**Flood Control Project Maintenance
Levee Inspections**
LMA District Cover Sheet
Spring 2019 Levee Inspection Results

Reclamation District No. 0556 Upper Andrus

Levee Inspection Report By Mile - Spring 2019

Photo 1 of 1 : SP_2019_RD0556_18_21_20190311_00002.jpg

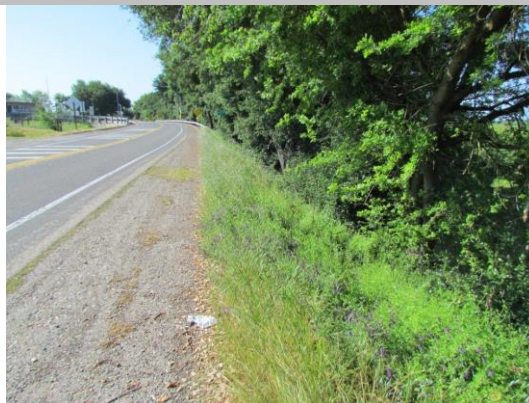
LM Start	0.08	Rating **	U	Issue No.	21
LM End	0.58	Issue Type +	Ma	Location *	LS
Category	Earthen Levee			GPS Latitude/Longitude	
				Start	End
Item	Vegetation			38.238037 °	38.231927 °
				-121.518067 °	-121.522215 °
DWR ID	DWR_RD0556_01_s_2017_21				
Comment Code					
V7 : Trees / Woody Vegetation					
Inspector Comment					
Control the wild growth and trim the trees so the slope can be seen.

Looking downstream from levee mile 0.09 woody tree growth and wild weeds covering the levee slope and shoulder landside levee section.

Photo 1 of 1 : SP_2019_RD0556_18_24_20190311_00006.jpg

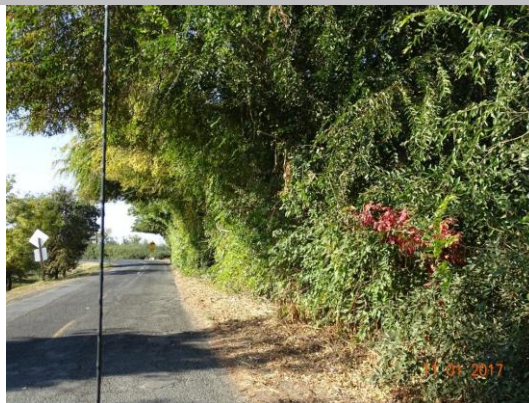
LM Start	0.87	Rating **	U	Issue No.	24
LM End	0.92	Issue Type +	En	Location *	LS
Category	Earthen Levee			GPS Latitude/Longitude	
				Start	End
Item	Vegetation			38.228820 °	38.228480 °
				-121.525853 °	-121.526470 °
DWR ID	DWR_RD0556_01_f_2017_24				
Comment Code					
V6 : Landscaping					
Inspector Comment

Trim/thin landscaping to allow inspection and access to levee slope and toe.

Photo 1 of 1 : SP_2019_RD0556_19_25_20190311_00009.jpg

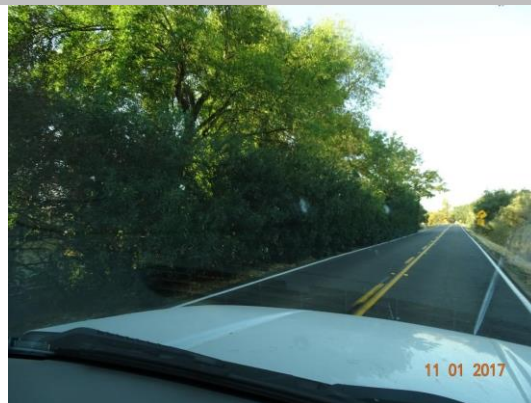
LM Start	0.55	Rating **	M	Issue No.	25
LM End	0.55	Issue Type +	En	Location *	LS
Category	Earthen Levee			GPS Latitude/Longitude	
				Start	End
Item	Vegetation			38.237810 °	38.237810 °
				-121.528182 °	-121.528182 °
DWR ID	DWR_RD0556_02_f_2017_25				
Comment Code					
V6 : Landscaping					
Inspector Comment					
Trim/thin oleanders on the landside of the levee.

View of oleanders on the landside of the levee.

Photo 1 of 1 : SP_2019_RD0556_19_46_20190311_00024.jpg

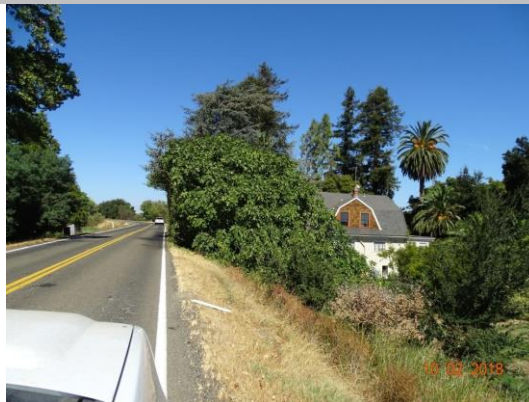
LM Start	2.29	Rating **	M	Issue No.	46
LM End	2.86	Issue Type +	En	Location *	LS
Category	Earthen Levee			GPS Latitude/Longitude	
				Start	End
Item	Vegetation			38.236980 °	38.229195 °
				-121.557782 °	-121.555337 °
DWR ID	DWR_RD0556_02_f_2018_46				
Comment Code					
V6 : Landscaping					
Inspector Comment

View looking upstream at beginning of landscaping on landside (October 2018).

Photo 3 of 3 : UCIP_SP_2019_12546_20315.jpg

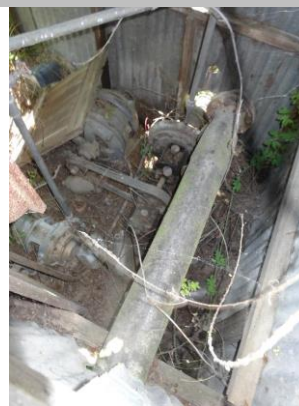
LM Start	4.54	Rating **	M	Issue No.	96 (cont)
LM End	4.54	Issue Type +	En	Location *

WS- abandoned gate valve, pump, and pipe in pump house
